DOCUMENT 00 9113 – ADDENDUM #2

A. Project Name: **Sandoval County Sheriff & Emergency Operation Center**
B. Owner Project Number: **FY22-SCPW-05**
C. Owner: **Sandoval County**
D. Architect: **RMKM Architecture, P.C.**
E. RMKM Architect Project Number: **1904**
F. Date of Addendum: **11 February 2022**

A1 ES101 ELECTRICAL SITE PLAN

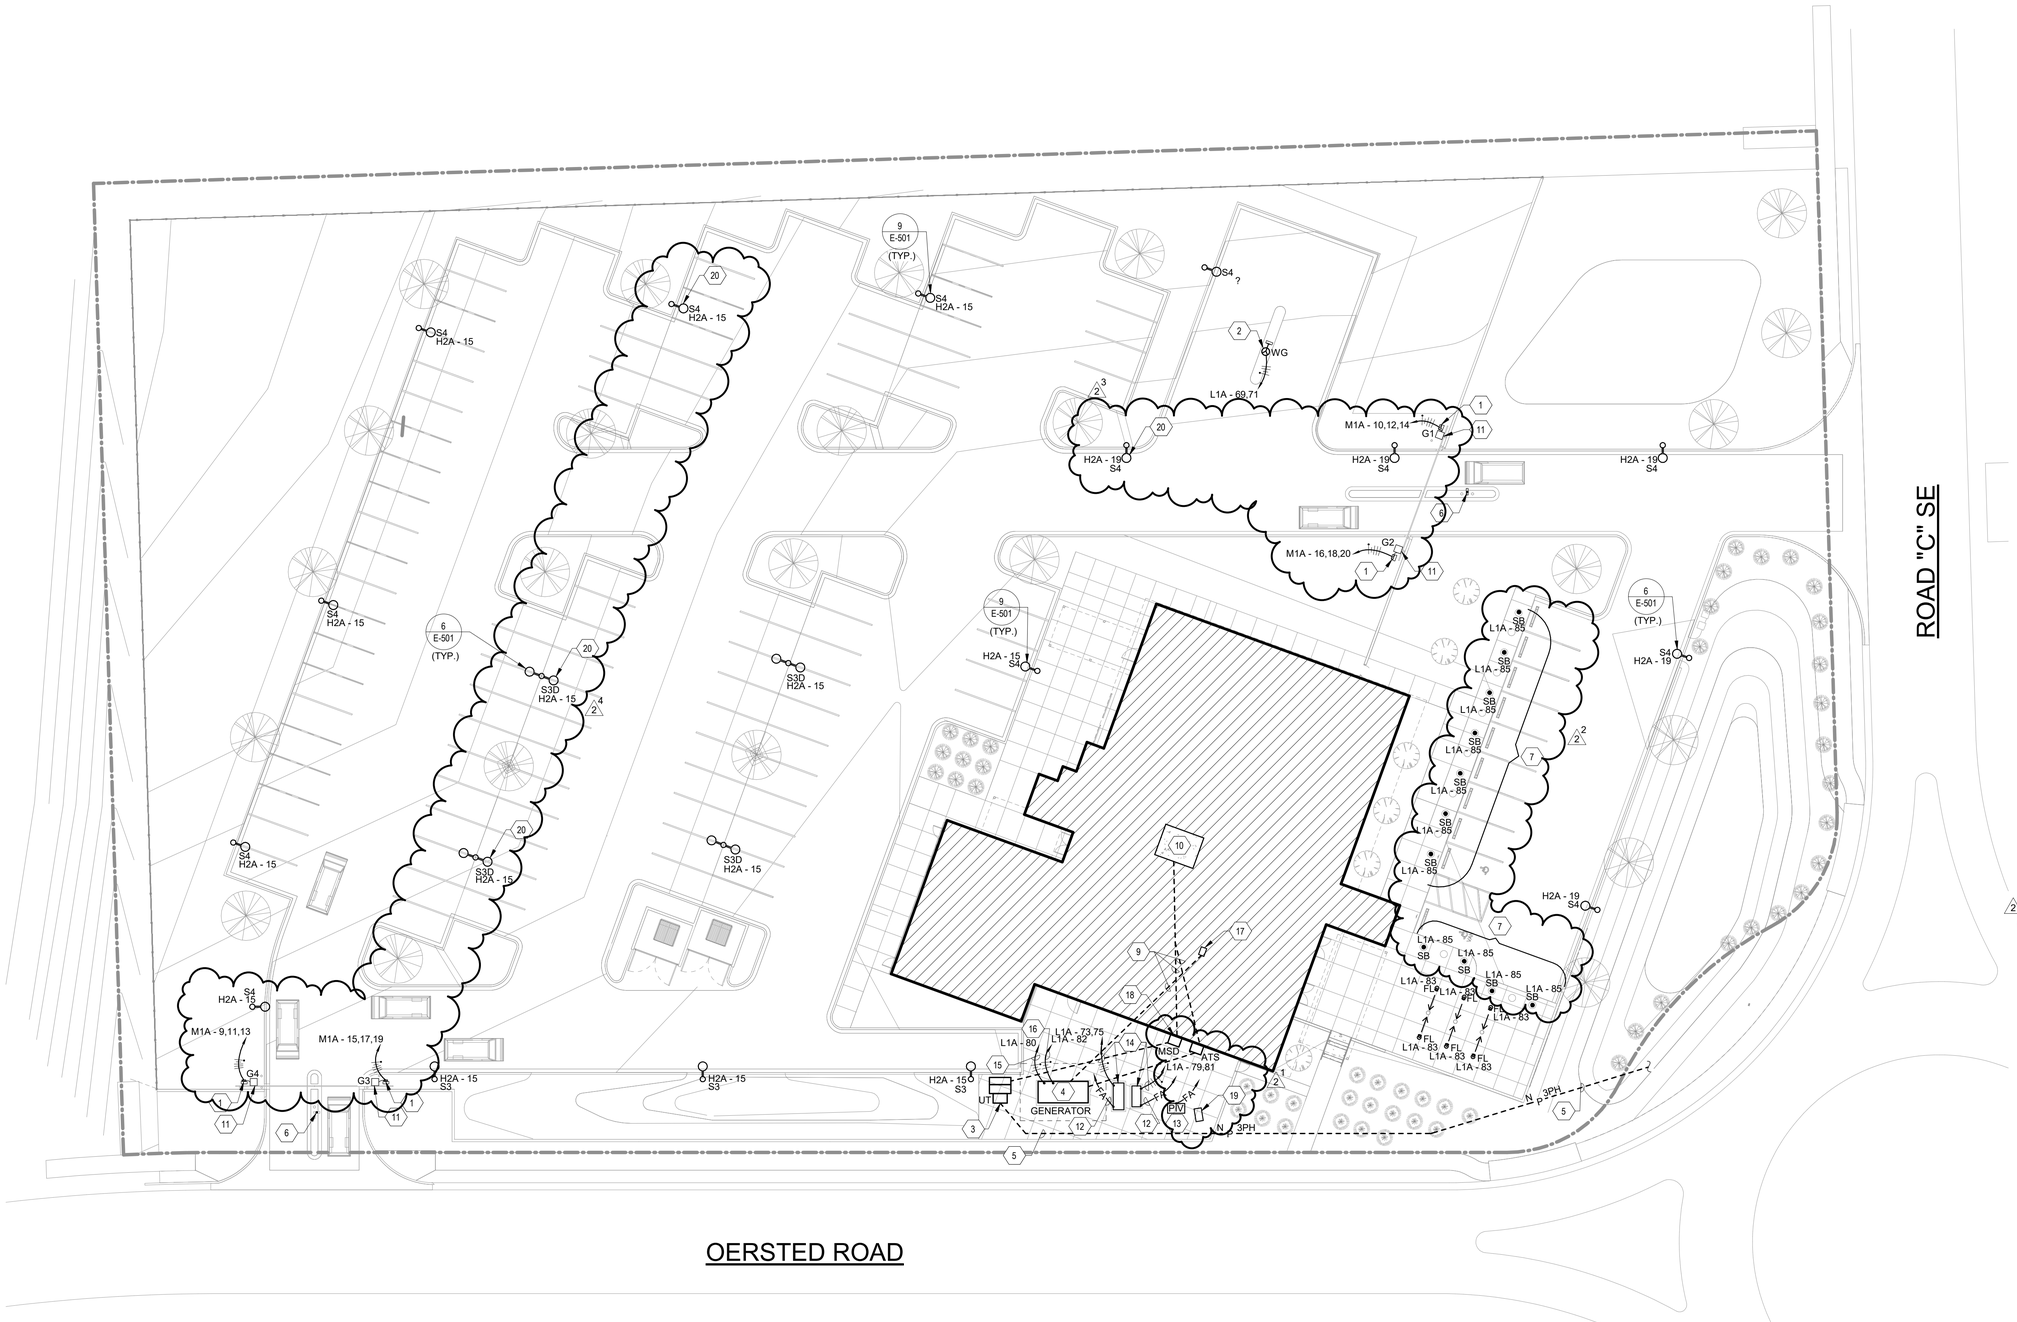
A. ES101
   1. Clarification for utility yard equipment
   2. Clarification for entry gates.
   3. Clarification and added notes for camera on poles in the parking area.
B. EL101
   1. Changed all “EMC” to “EM” types.
   2. Added D1 type luminaires to stair wells.
   3. Added E1 type lumianre at lobby.
   4. Updated General Notes.
   5. Add note 9.
   6. Add note 5 to room 129 devices.
C. EL102
   1. Changed all “EMC” to “EM” types.
   2. Added D1 type luminaires to stair wells.
   3. Added EM type luminaires.
   4. Updated General Notes.
   5. Add plan for Penthouse lighting.
D. EP101
   1. Adjusted notes for FC1 and FC2.
   2. Added power to IT rack in room 104.
   3. Added circuit information for electronic bell.

A1 / EL101 LIGHTING LEVEL 01 FLOOR PLAN
1/8" = 1'-0"

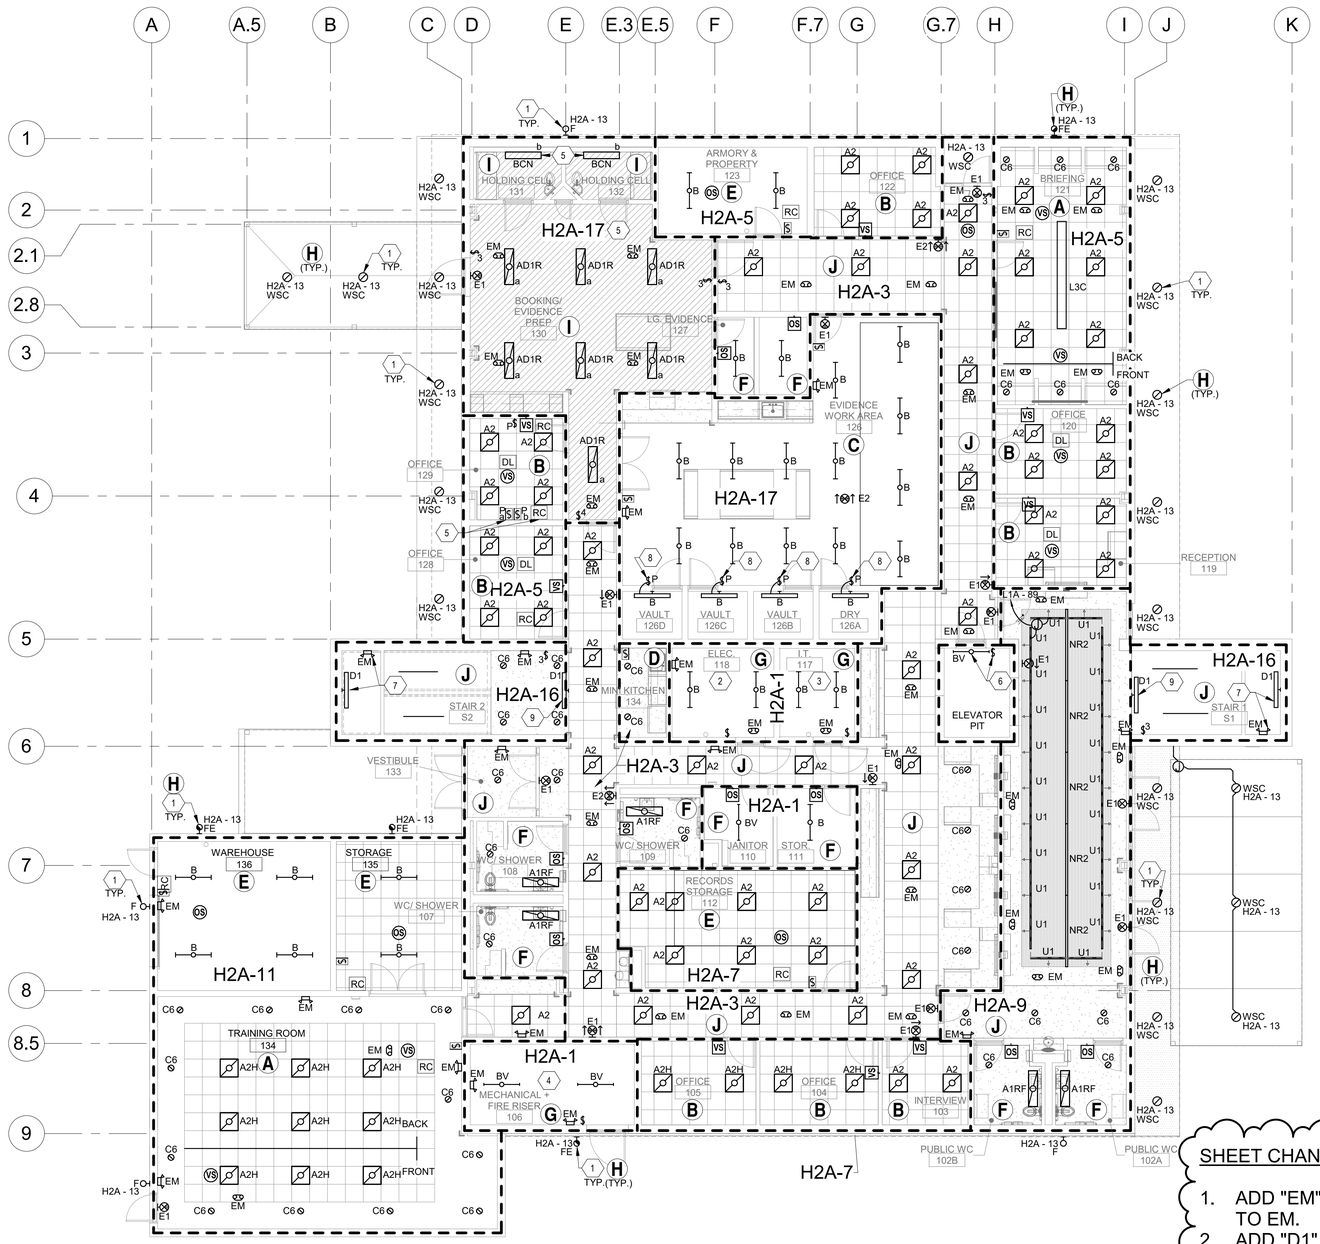
1. ADD "EM" LUMINAIRES. CHANGE EMC TO EM.
2. ADD "D1" LUMINAIRES AT STAIRS.
3. ADD "B" LUMINAIRES.
4. ADD "E1" AT LOBBY DOOR.
5. GENERAL NOTE " UPDATE.
6. ADD NOTE 9.
7. ADD NOTE 5 TO ROOM 129 DEVICES.

A1 EL102 LIGHTING LEVEL 02 FLOOR PLAN
1/8" = 1'-0"

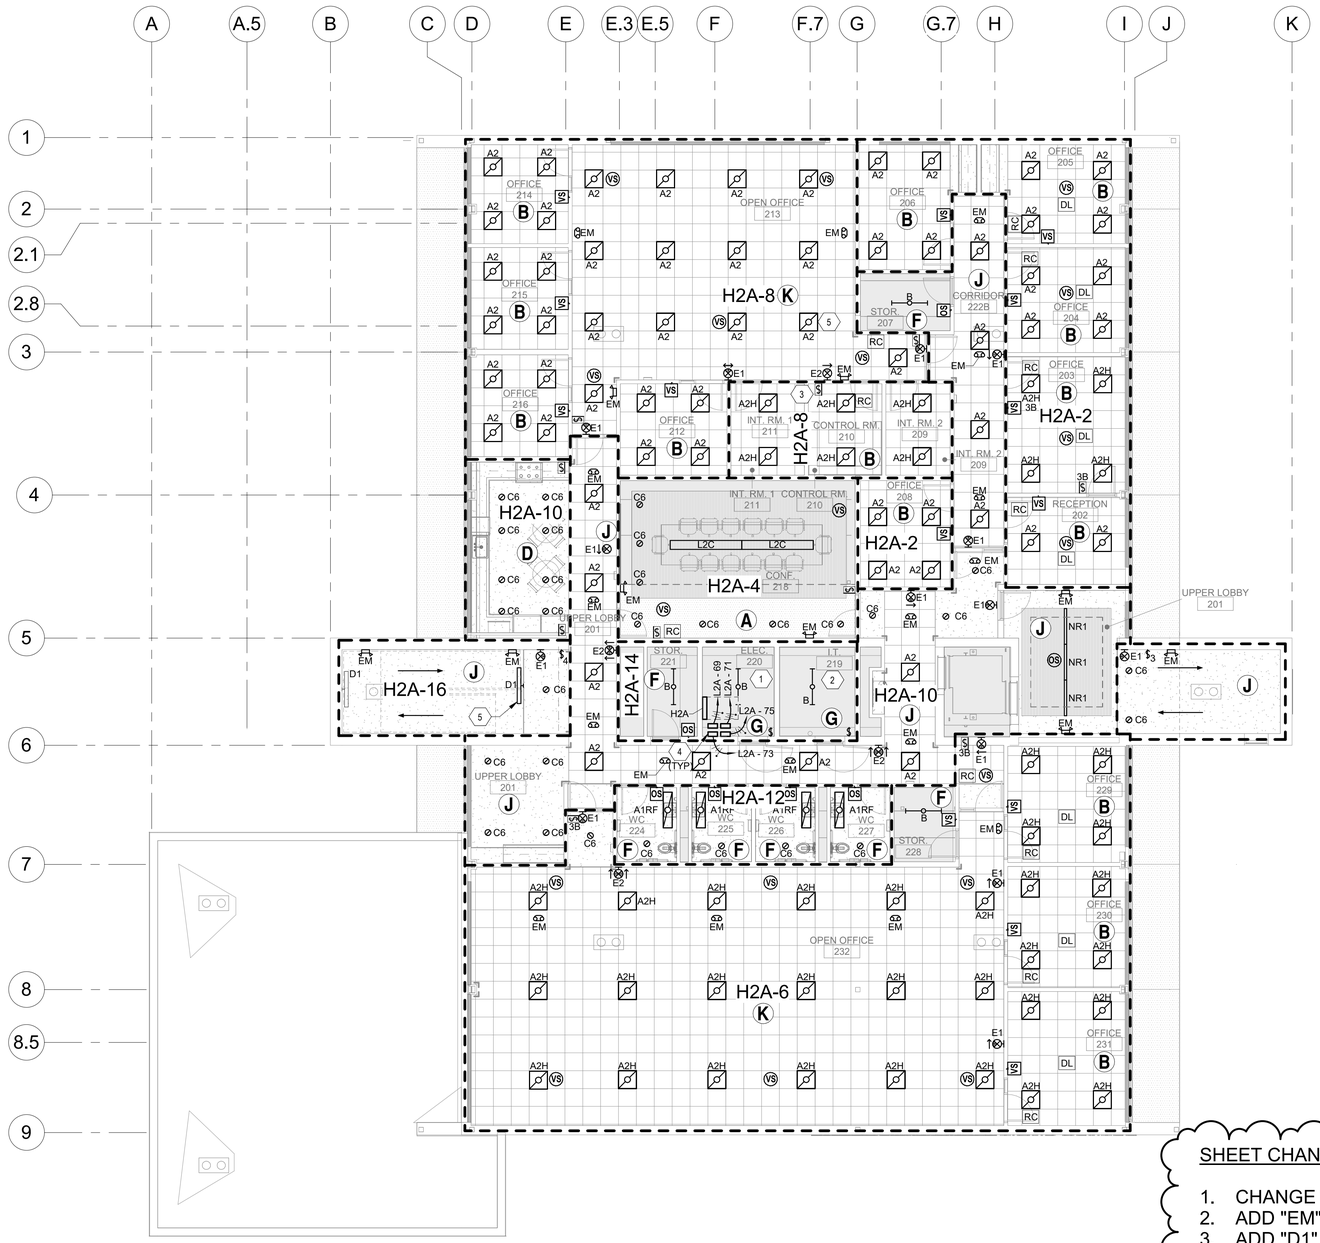
1. CHANGE "EMC" LUMINAIRES TO "EM".
2. ADD "EM" LUMINAIRES.
3. ADD "D1" LUMINAIRES AT STAIRS.
4. UPDATED ALL GENERAL NOTES.
5. UPDATED NOTE 3.
6. ADDED NOTE 5 AND 6
7. ADDED PENTHOUSE PLAN.
8. ADD LIGHTING CONTROL SEQUENCE TO ROOM 210.

A3 EP101 POWER LEVEL 01 FLOOR PLAN
1/8" = 1'-0"

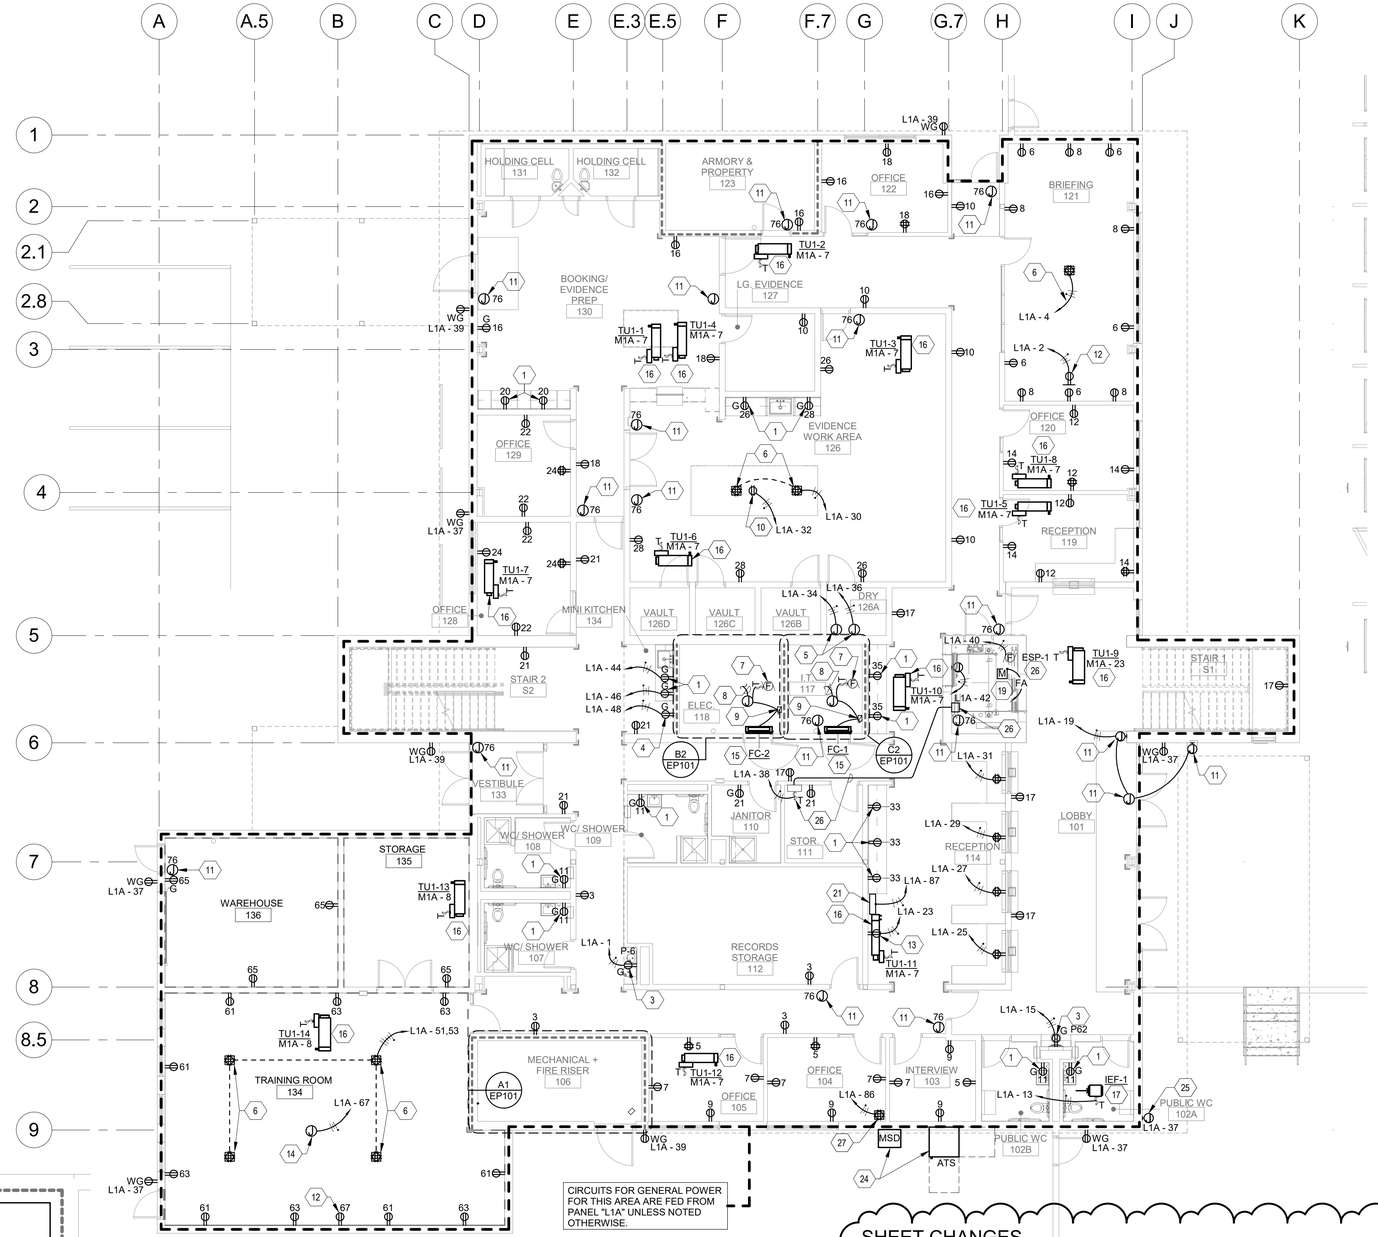
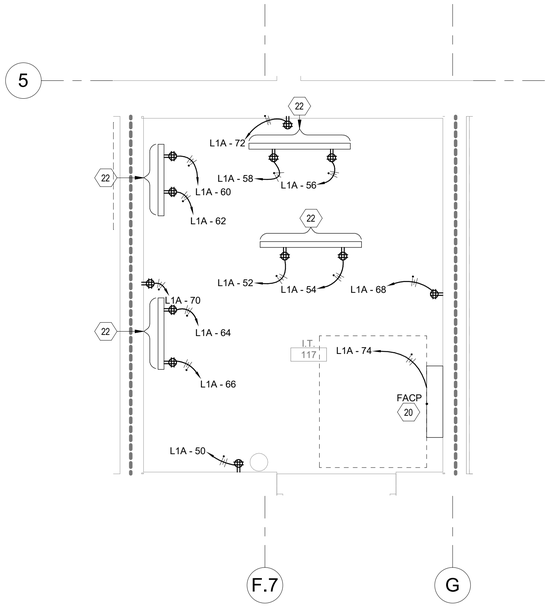
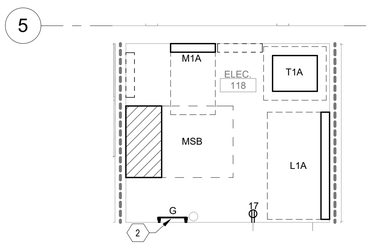
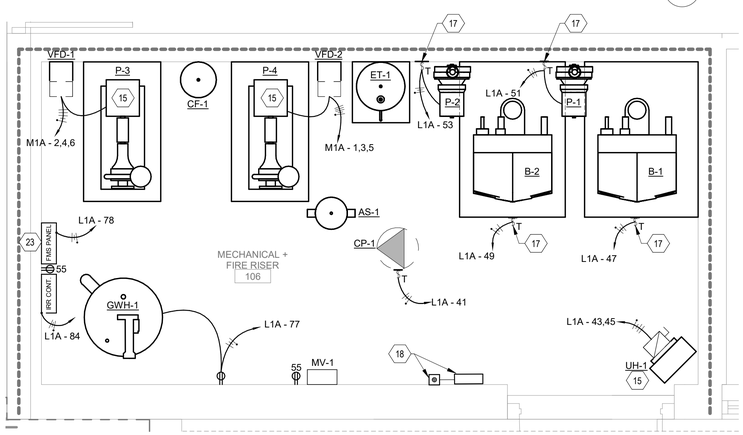
1. ADJUST NOTES FOR FC2 AND FC1.
2. ADD POWER FOR RACK IN ROOM 104 & QUADPLEX RECEPTACLES.
3. ADD CIRCUIT INFORMATION FOR ELECTRONIC BELL.
4. ADJUSTED EXTERIOR ELECTRICAL EQUIPMENT SIZE.
5. ADD NOTES 25 THROUGH 27.
6. ADD POWER AND NOTES TO EXTERIOR DOOR AT 1/G.7
7. ADJUSTED FLOOR BOXES TO MATCH "T" SHEETS.

A3 EP102 POWER LEVEL 02 FLOOR PLAN

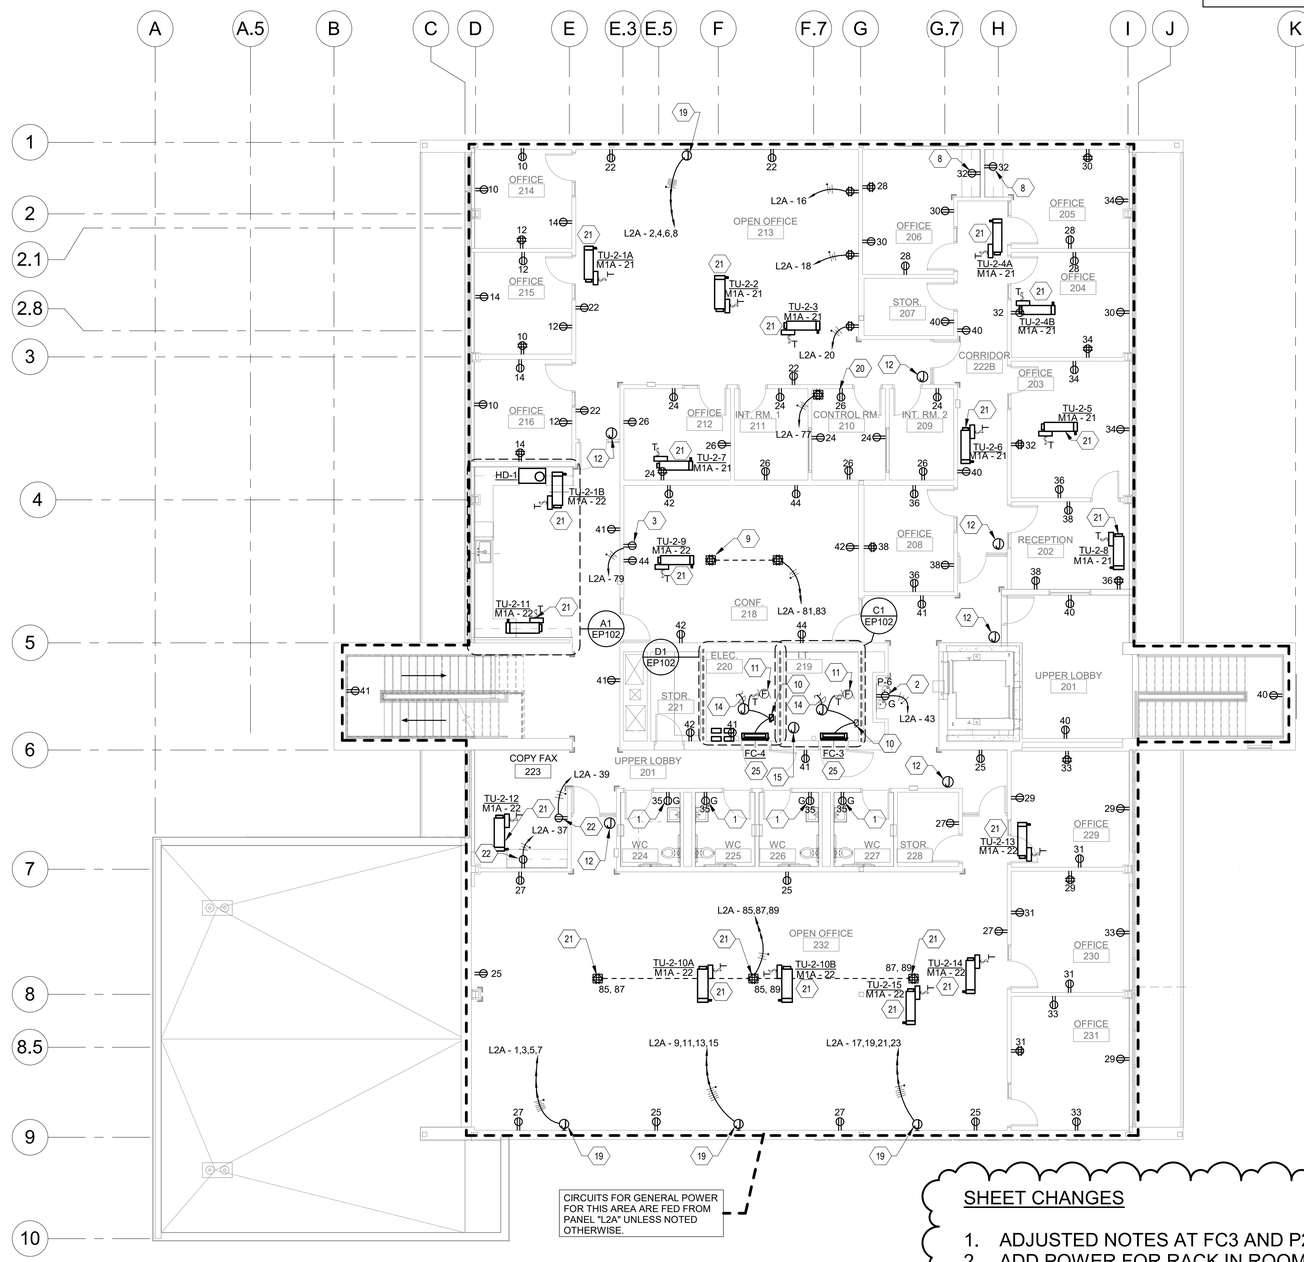
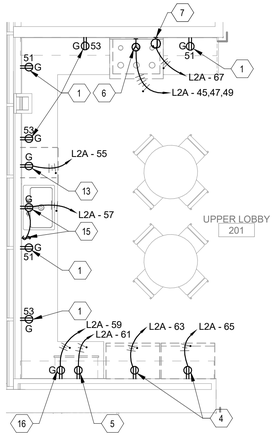
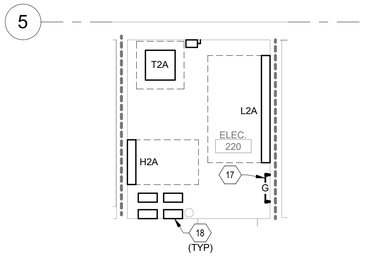
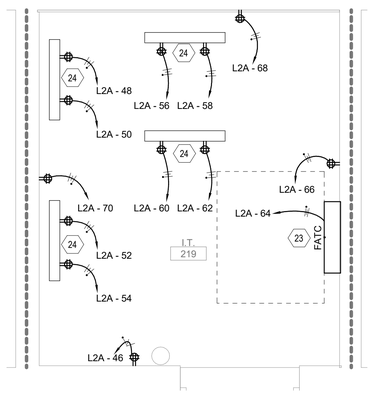
E. EP102?
1. Adjusted notes for FC3 and FC4.
2. Added power to IT rack in room 210.
3. Add note 25.
4. Change note 20.
5. Added note 18 and 19.
6. Adjusted not 18 to 19 in room 213
7. Adjusted enlarged plan A1.
8. Adjusted floor boxes to match "T" sheets.

1. ADJUSTED NOTES AT FC3 AND P24.
2. ADD POWER FOR RACK IN ROOM 210 AND QUADPLEX RECEPTACLE.
3. ADDED NOTE 25.
4. CHANGE NOTE 20.
5. ADJUSTED FLOOR BOXES TO MATCH "T.
6. CHANGED NOTE 18 TO 19 AT NORTH WALL OF ROOM 213.
7. ADJUST INFORMATION TO A1 ENLARGED PLAN
